**Re: Planning Application PINS Reference: S62A/22/0006 (the “Application”)  
Uttlesford District Council (the “Council”) Reference UTT/22/2046/PINS  
Development of a ground mounted solar farm with a generation capacity of up to  
49.99MW, together with associated infrastructure and landscaping (the  
“Proposed Development”)  
Land At Berden Hall Farm, Ginns Road/Pelham Road, Berden (the “Site”)  
Berden Solar Limited (the “Applicant”)**

With regards to the above section 62a planning application, we refer to our original objection letter dated 5<sup>th</sup> September 2022 and the updated Construction Traffic Management Plan (“CTMP”) and associated plans as further submitted by the Applicant in October 2022.

1. Narrow road at junction Farnham Road and Hazel End Road, Farnham, CM23 1HB

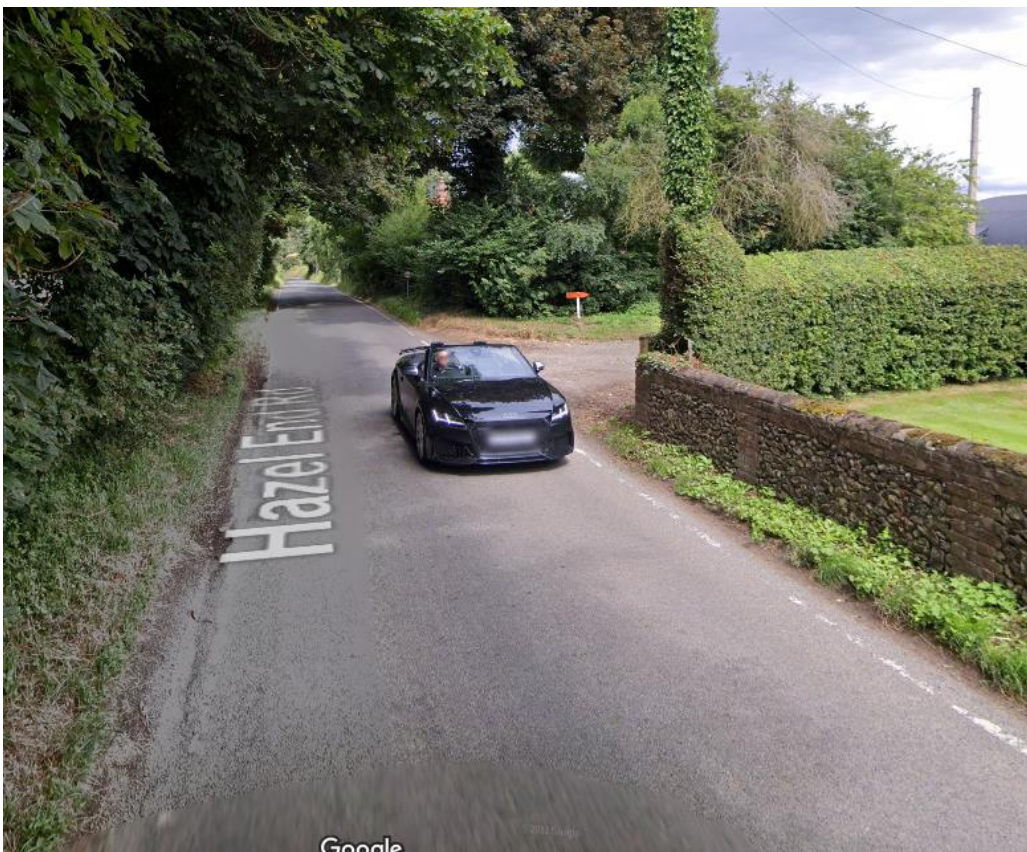
2. The Google street view photos shown within the CTMP do not show several pinch points and traffic concerns. These are shown overleaf and show several incidences of narrow roads where cars cannot pass each other let alone cars and HGVs. This includes the front of Manuden Primary School.
